**Environmental  
Planning  
Commission**

**Agenda Number: 02  
Project Number: 1009414  
Case #: 12EPC -40061  
December 6, 2012**

**Staff Report**

<b>Agent</b>	Mikaela Renz-Whitmore
<b>Applicant</b>	City of Albuquerque
<b>Request(s)</b>	<b>Recommend Adoption of the Volcano Heights Sector Development Plan (SDP)</b>
<b>Legal Description</b>	See attached map
<b>Location</b>	Paseo del Norte on the north and south, Universe Blvd. on the west, Petroglyph National Monument on the east
<b>Size</b>	Approximately 569.11 acres
<b>Existing Zoning</b>	RD, SU-1 PRD FAR. 5, SU-1 C-1 USES
<b>Proposed Zoning</b>	SU-2 VHTC (Town Center), SU-2 VHRC (Regional Center), SU-2 VHVC (Village Center), SU-2 VHMIX (Mixed Use), SU-2 VHNT (Neighborhood Transition), and/or SU-2 VHET (Escarpment Transition)  General Design Regulations are associated to varying degrees with all properties within the Volcano Heights SDP boundary.

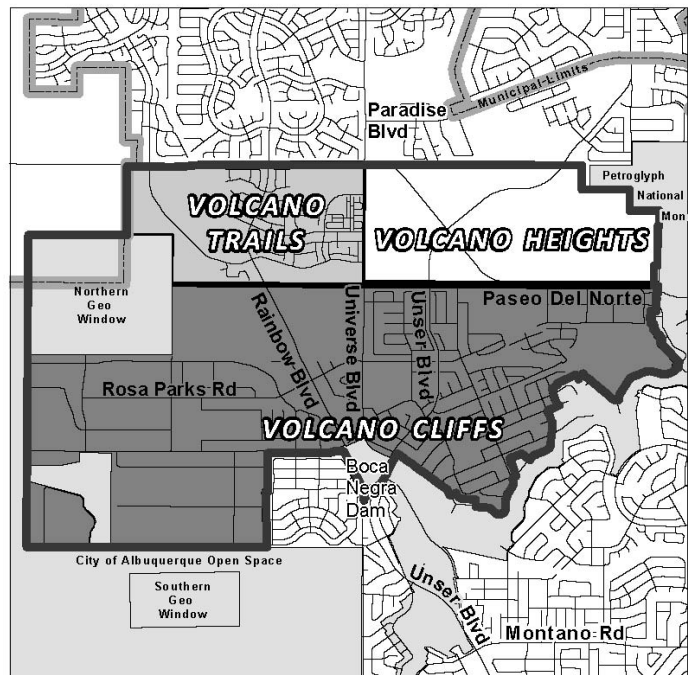
- Pg 4 Text 1.1 Boundary description is not in accordance with Exhibit 1.1. Universe Blvd. is mislabeled on the territory map. Please correct.
- Pg 18 According to sector plan, paragraphs 2.1.4, 2.1.5, regulations of this plan supersede COA Subdivision Ordinance and DPM. Many of the proposed development designs conflict with currently applied guidelines, standards and regulations. Will proposed street layouts be justified by a transportation engineer?

4. Pg 4 Universe Blvd. is mislabeled on the territory map. Please correct.
5. Pg 57 Please clarify intent of Exhibit 4.3 by text that refers to this signalized layout as "illustrative" and add the symbols +/- beside all numerical measurements.

2. On page 5, Exhibit 1.1, edit labels to show correct placement of Universe Blvd., Unser Blvd, and Golf Course Rd. [AC 21]
3. On page 8, section 1.7.2(ii), insert the following text: "The optional bonus height system is intended to provide additional height and density incentives for development in appropriate locations that enhances the built and natural environments." [PC 145]
